D14-ONT (Ertl) 2nd Submission Comment Summary

Re: Zoning By-law Amendment, 2nd Submission
6676-6678 Wellington Road 34
Township File No.: D14-ONT - 6678 Wellington Rd 34
Our File No.: 124

Hydro-Vac Truck Disposal Area: 6678 County Road 34, Puslinch Township

**Re: Peer Review of Acoustic Assessment Report
 Waste Processing Facility
 Puslinch, Ontario
 VCL File: 122-0269**

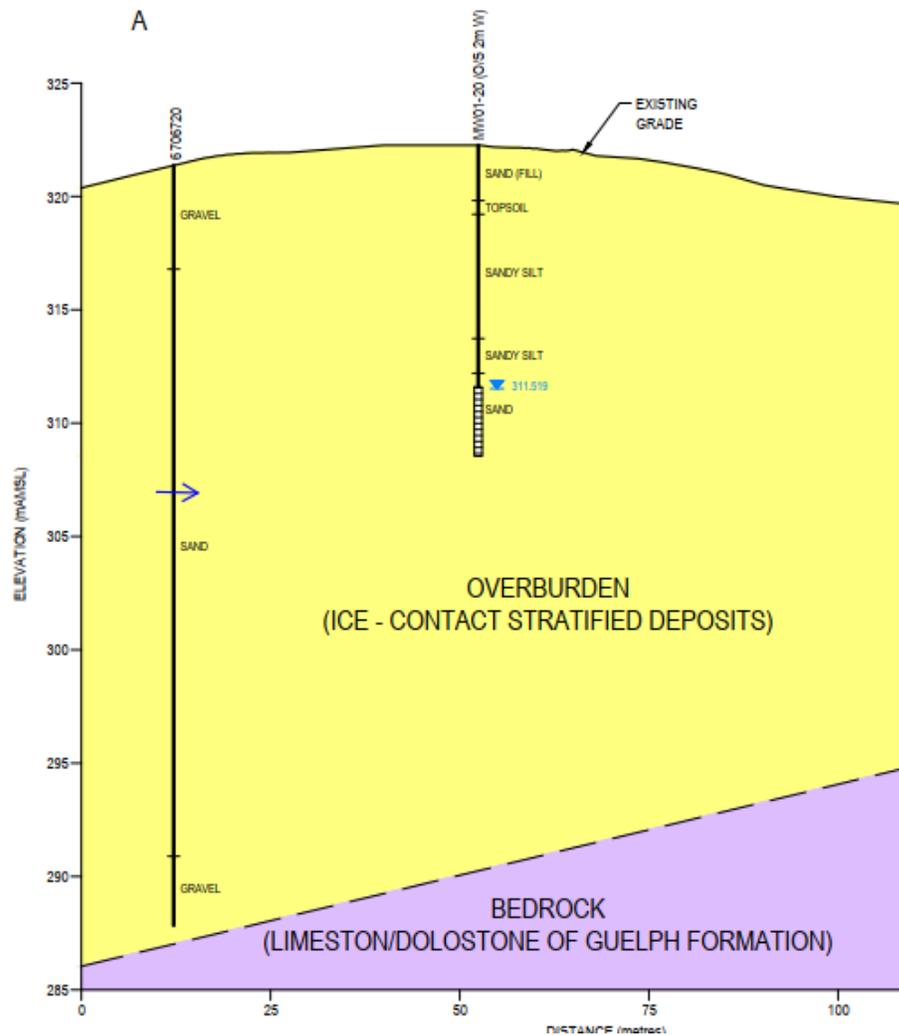
Neither MW01-20 nor nearby private well 6706720 shown below from Figure 3.8, December 2020 supporting documentation prepared by GHD indicate protective layers above the bedrock aquifer or above the overburden aquifer.

The presence of chloride from on-site activities is a clear indication of the movement of chemicals from the ground surface to the underlying aquifer. It is our opinion that a slurry of water and soil that have not been tested for their chemical constituents should not be imported to this site and released. The potential for the release of known chemicals, including chemicals of concern that are not on the ECA list and future chemicals of concern should make this site ineligible for such releases.

The presence of polyaromatic hydrocarbons diethyl phthalate, fluoranthene, fluorene, 1+2-methylnaphthalenes, 1-methylnaphthalene, 2-methylnaphthalene, naphthalene, phenanthrene, phenol, pyrene detected in the monitoring wells is another indication that anthropogenic chemicals are being introduced to the groundwater system.
